Staff Report

To: Salt Lake City Historic Landmark Commission
From: Katia Pace, Principal Planner (801)-535-6354, katia.pace@slcgov.com
Date: November 3, 2022
Re: PLNHLC2022-00242 – Minor Alterations for an addition and window openings

Minor Alteration

PROPERTY ADDRESS: 365 N Quince Street
PARCEL ID: 08-36-282-015-0000
MASTER PLAN: Capitol Hill Master Plan
ZONING DISTRICT: SR-1A, Historic Preservation Overlay (Capitol Hill)
DESIGN GUIDELINES: Residential Design Guidelines

South elevation – showing proposed new openings on historic structure and proposed windows in the addition

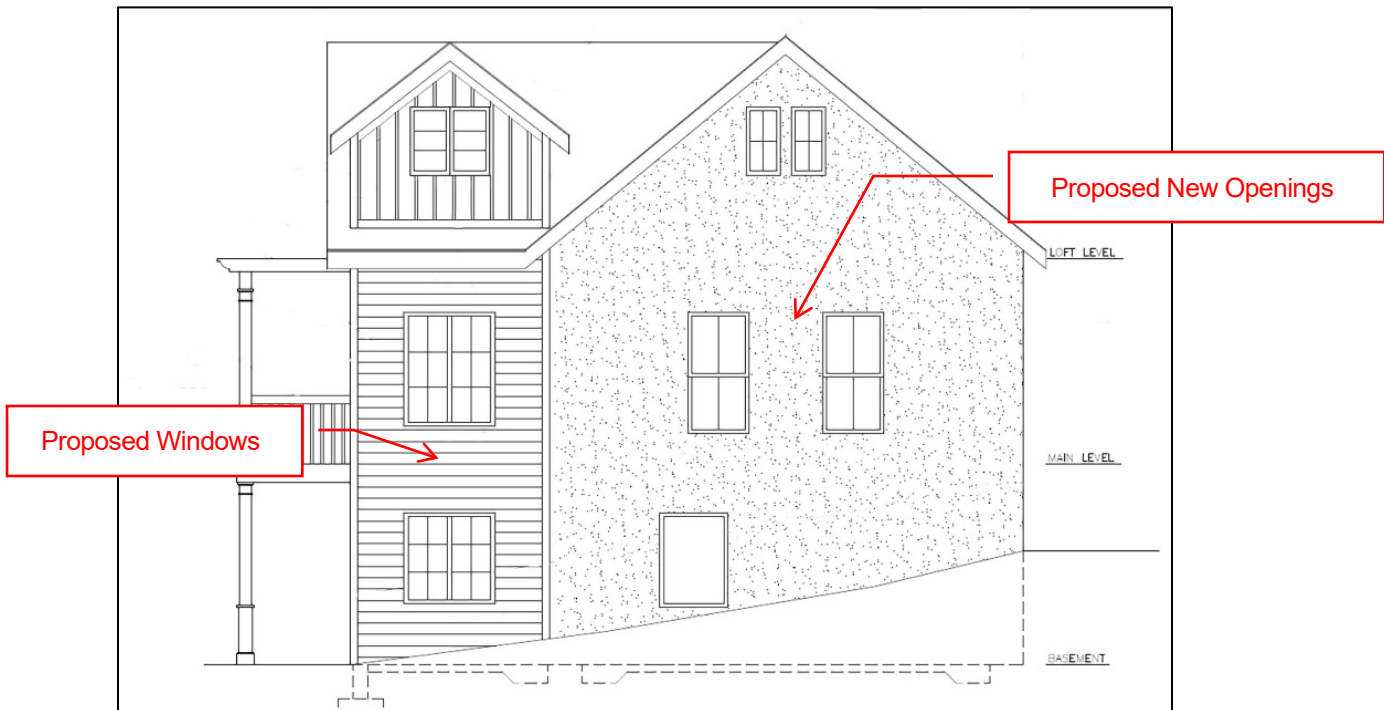
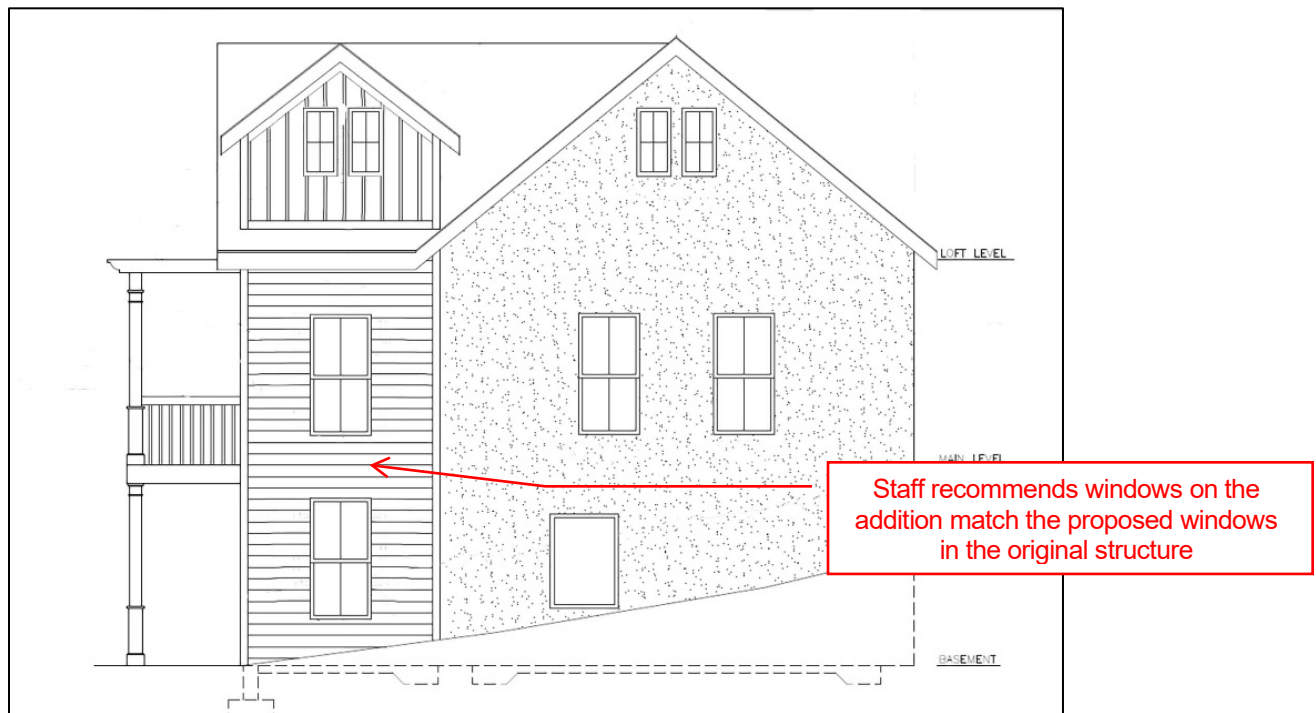
Issue 2 – New opening for windows

Since House #2 was built as a store, the adobe structure had no windows on the main floor of the south side. That wall had interior shelving for the store. The basement has one small window on the south side of the adobe structure. According to Chapter 3 - Windows, of the Residential Design Guidelines, adding window openings is generally inappropriate. However, this is an adaptive reuse from a store to a residential structure. New windows would not only provide a better living environment as a residential unit, but the ventilation offered by the windows will improve the efficiency and life span of the adobe bricks.

Findings: Staff finds that the proposed window openings are important to the preservation of this building by providing ventilation to an adobe structure and to transition from commercial to residential. House # 2 has a vernacular architectural style with a simple gable roof and end chimney. As such, the proposed two-over-two, cottage-style windows are appropriate to the structure's architectural style.

Issue 3 – Window styles should be similar

The proposal is for double hung windows in the historic structure and casement windows in the addition (see drawing above). In this case the windows on the historic building wouldn't be original. The following standard from the Residential Design Guidelines applies to the proposed windows:

8.10 The style of windows in the addition should be similar in character to those of the historic building or structure where readily visible.

- If the historic windows are wood, double-hung, for example, new windows should appear to be similar to them, or a modern interpretation.

Findings: The proposed windows on the addition will be visible from the street. Staff recommends that the windows in the addition match the proposed new windows on the South side of the historic building as a condition of approval.

East (front) and East (rear) Elevations – appearance is inconsistent

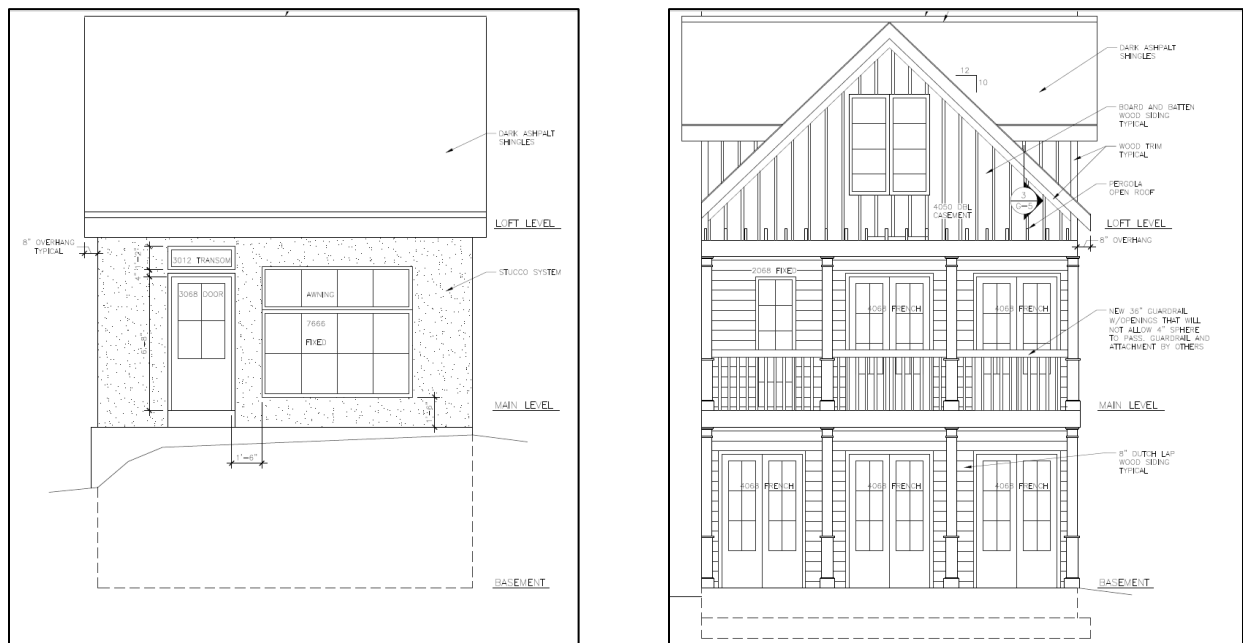
Issue 4 – Visual compatibility

The existing architectural style on the principal structure is simple vernacular and on the proposed addition the style is much more ornate. According to Chapter 8 – Additions, of the Residential Design Guidelines, the “appearance inconsistent with the historic character of the building is inappropriate”.
